November 27, 2023
GS# 321-269, Unit 17 Renovations
Mississippi State Penitentiary

Addendum No. 3

SHEET
C100R
SITE
DEMOLITION
PLAN

SHEET
ES101

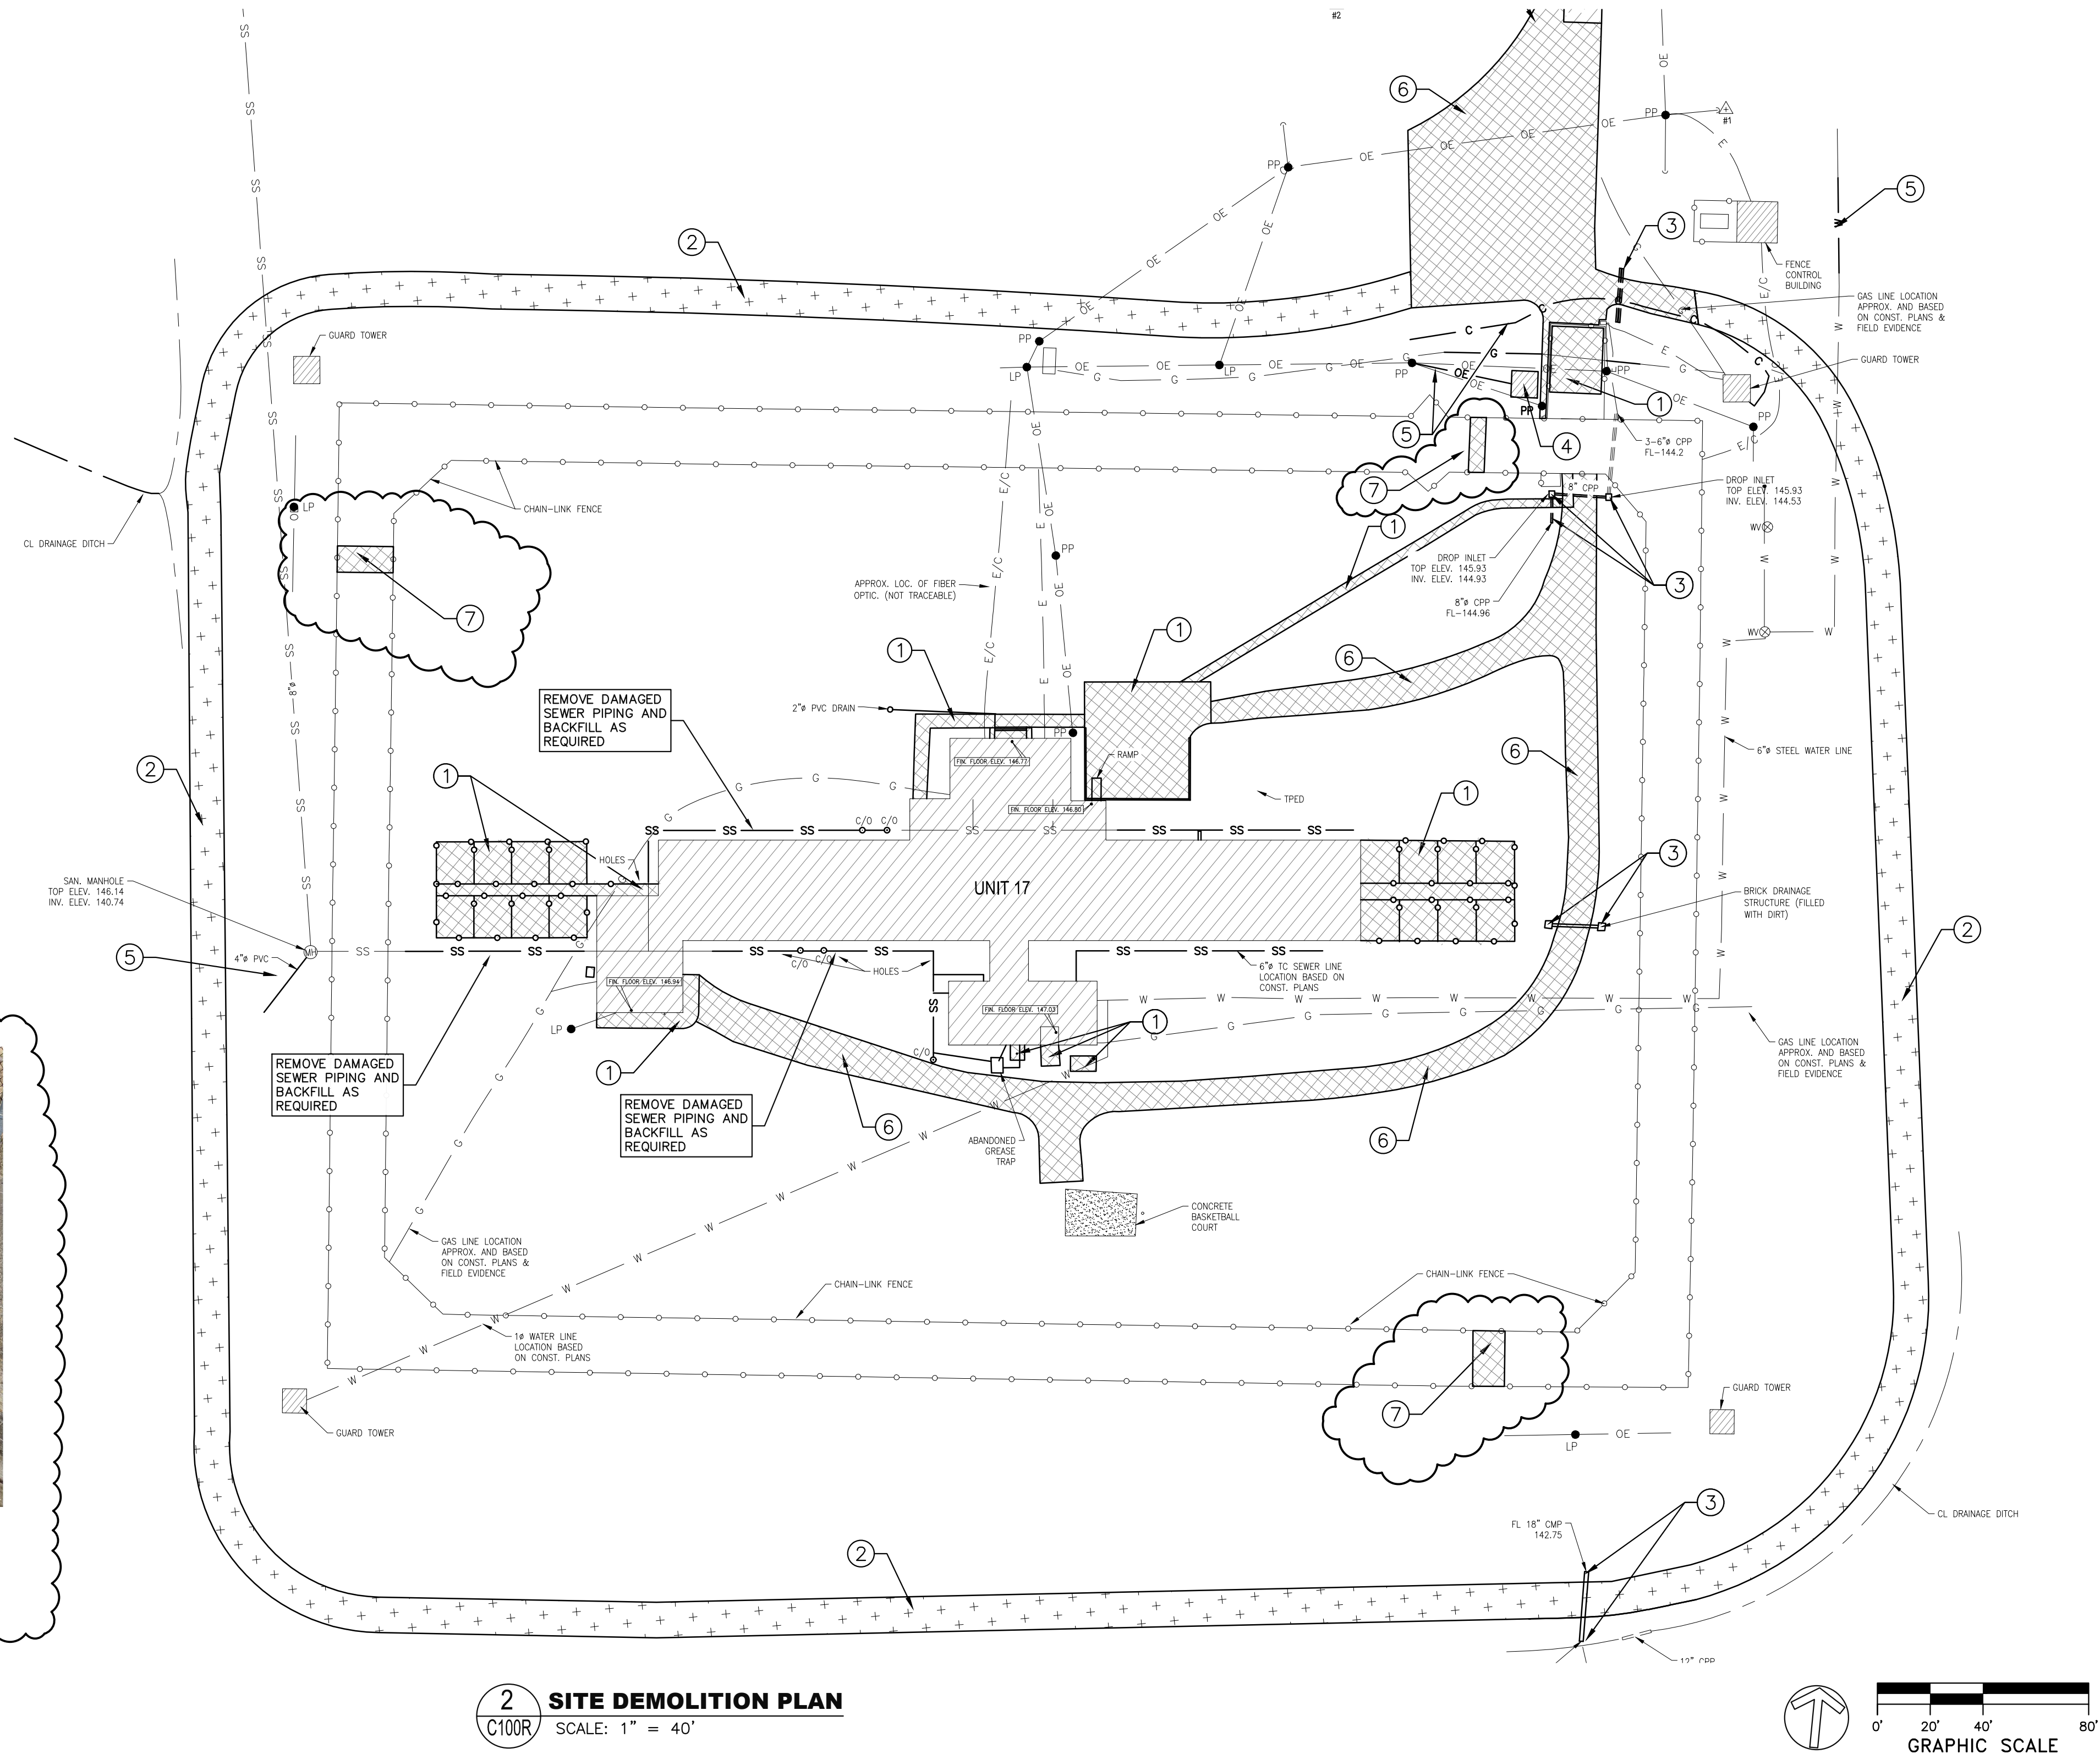
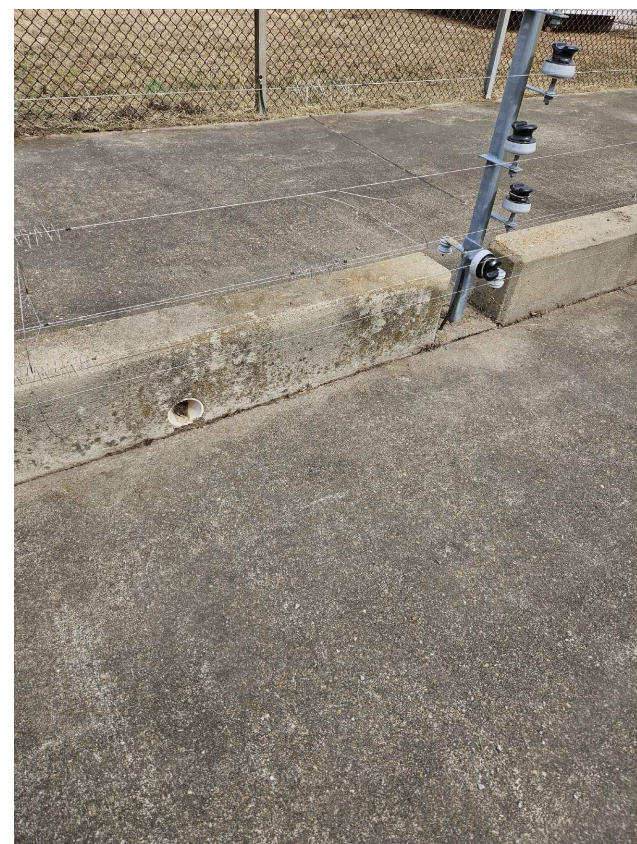
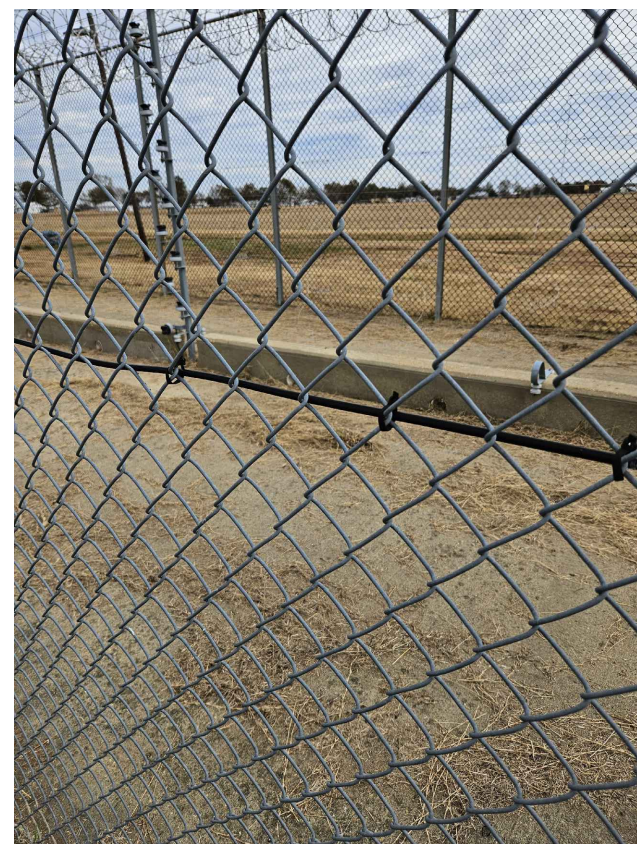
1. REMOVE EXISTING CONCRETE SIDEWALK/PAVEMENT.
2. RE-GRADE AND RESHAPE EXISTING GRAVEL.
3. REMOVE EXISTING DRAINAGE PIPING AND STRUCTURES.
4. REMOVE EXISTING BUILDING, ASSOCIATED STRUCTURES, AND ASSOCIATED UTILITIES TO ACCOMMODATE NEW CONSTRUCTION.
5. REMOVE EXISTING UTILITIES TO ACCOMMODATE NEW CONSTRUCTION.
6. REMOVE EXISTING GRAVEL TO ACCOMMODATE NEW CONSTRUCTION.
7. REMOVE AND REPLACE EXISTING PERIMETER CONCRETE AND CURBING. PROTECT EXISTING PERIMETER CHAINLINK AND ELECTRIC FENCING. SEE PHOTOS ON THIS PAGE.

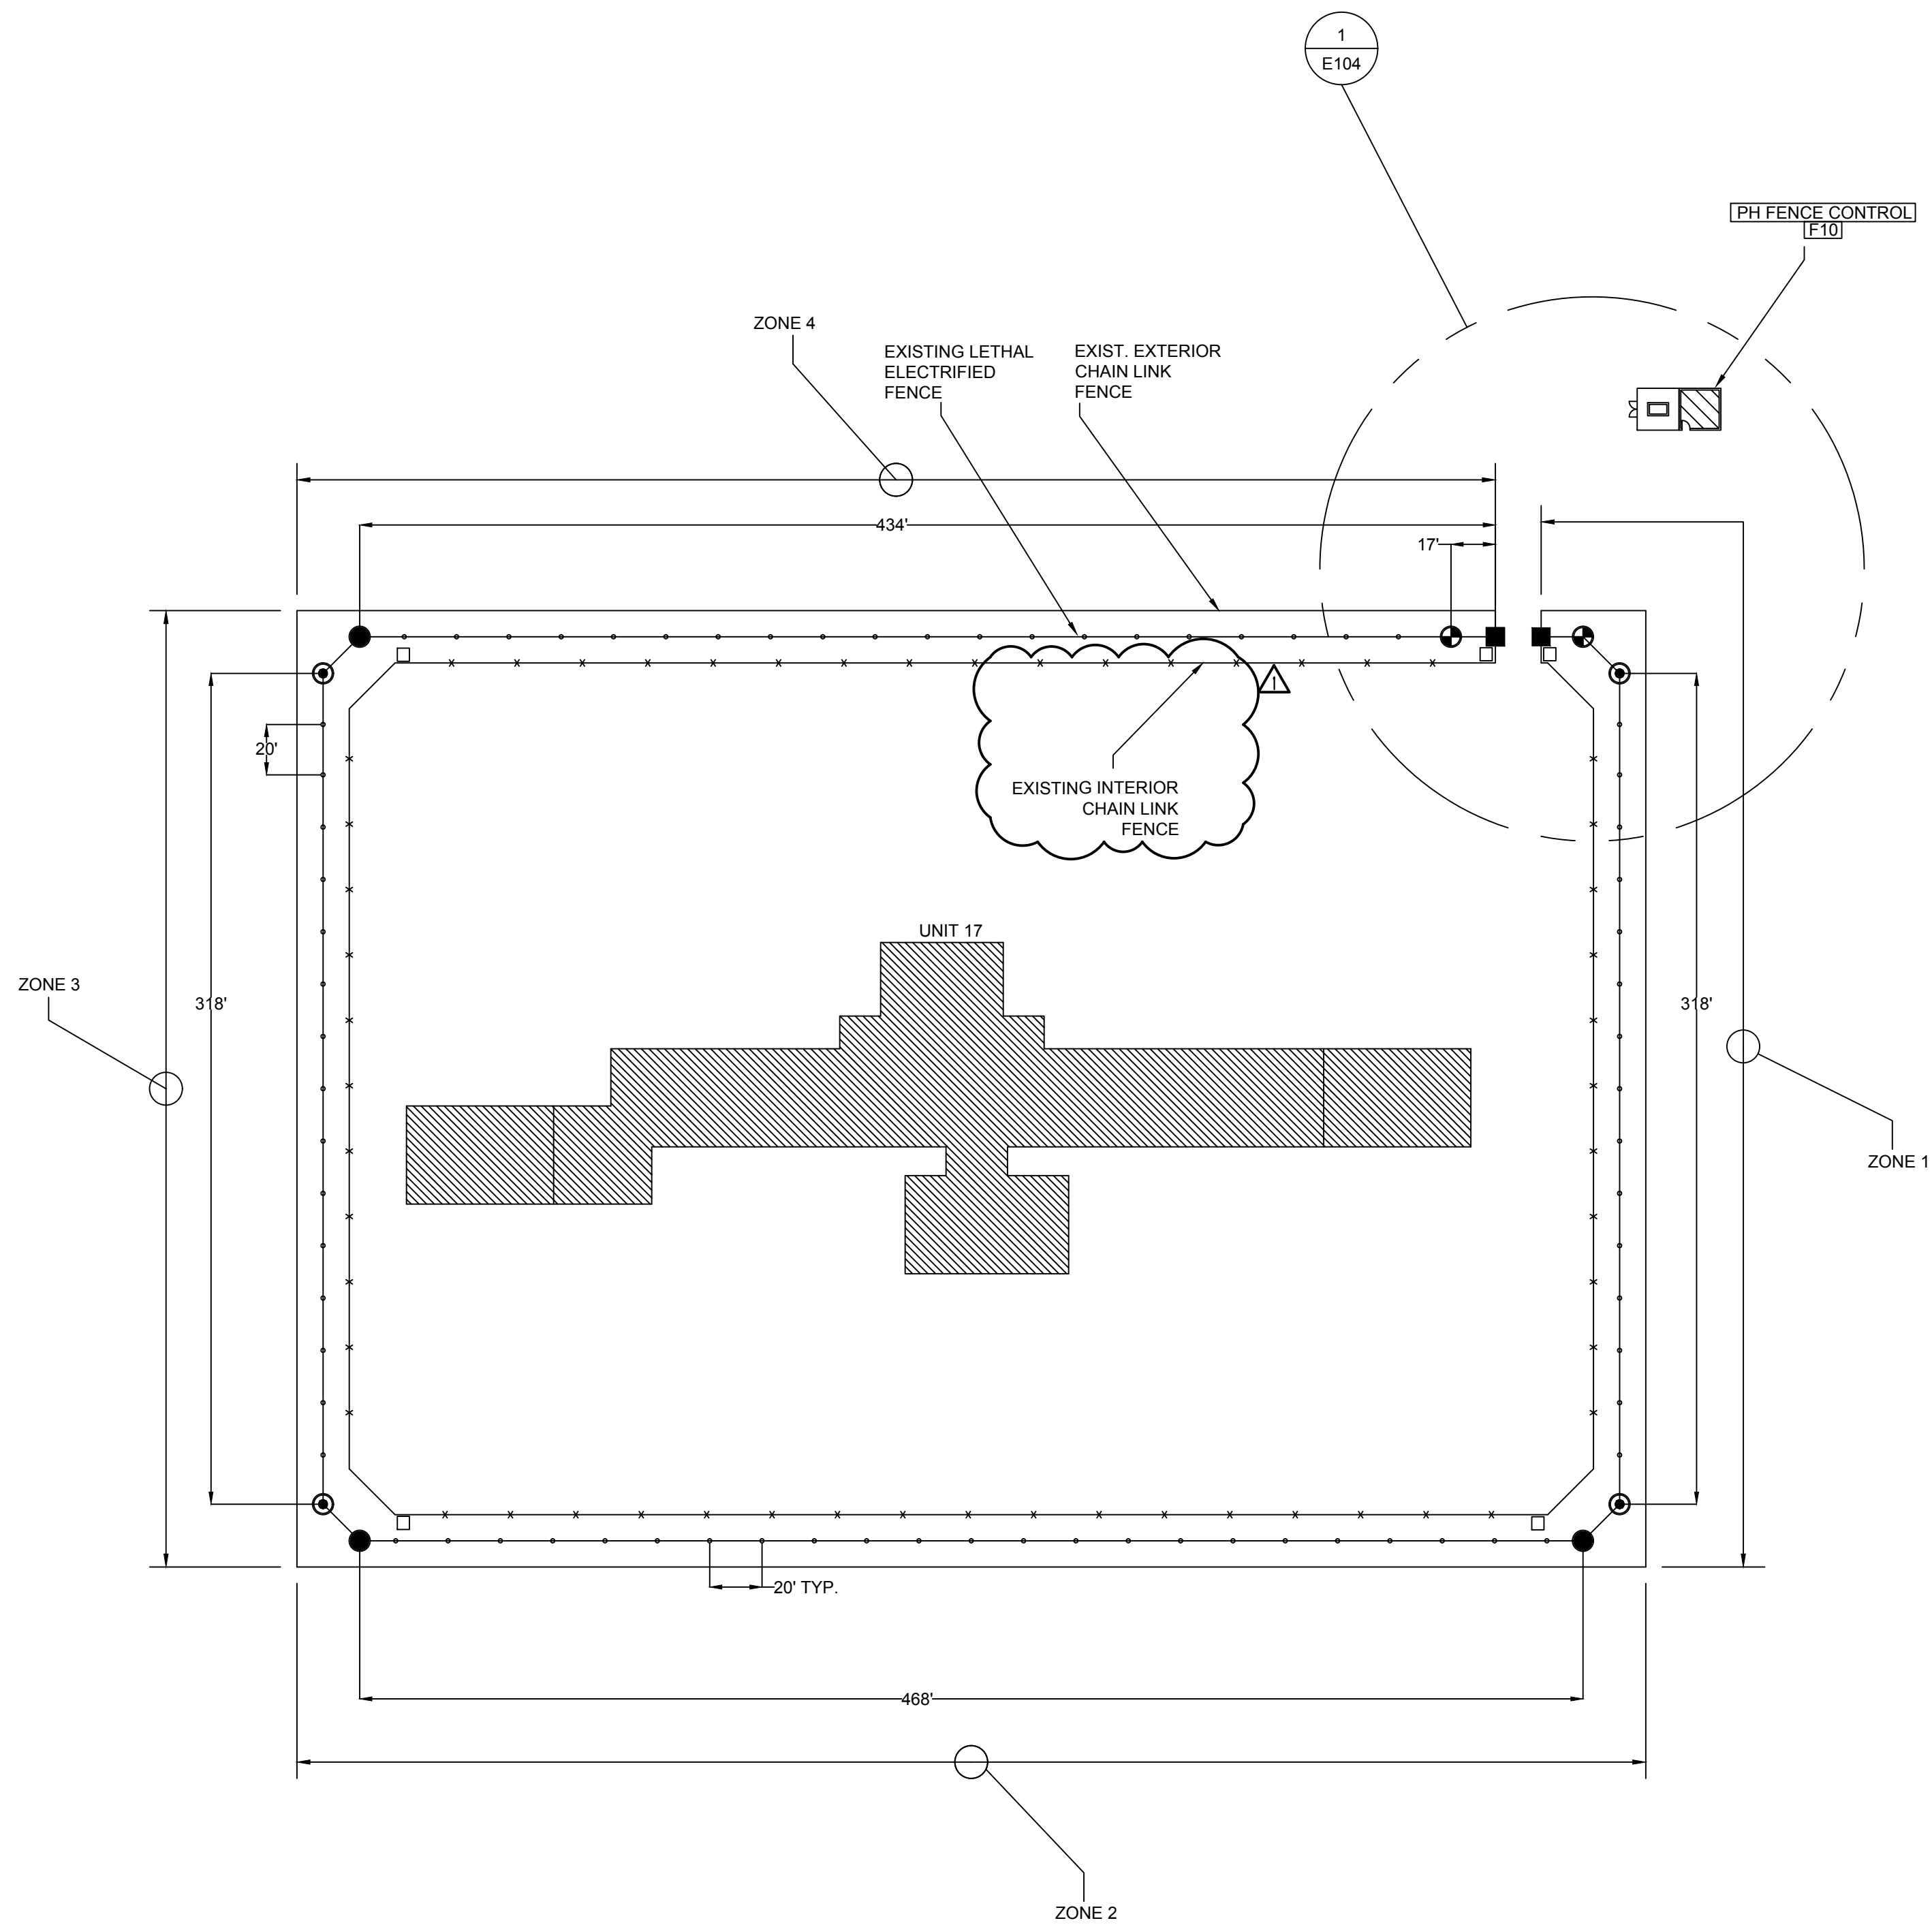
5. Drawing sheet ES101: Find attached to this addendum, revised drawing sheet ES101 (see clouded note) that has been revised to correctly indicate that the existing interior, perimeter chain link fence is to remain for reuse. A note on the originally issued ES101 incorrectly indicated that this fence was to be replaced. This original note is **not** correct, the existing fence, gates, etc. are to remain and be protected for reuse.
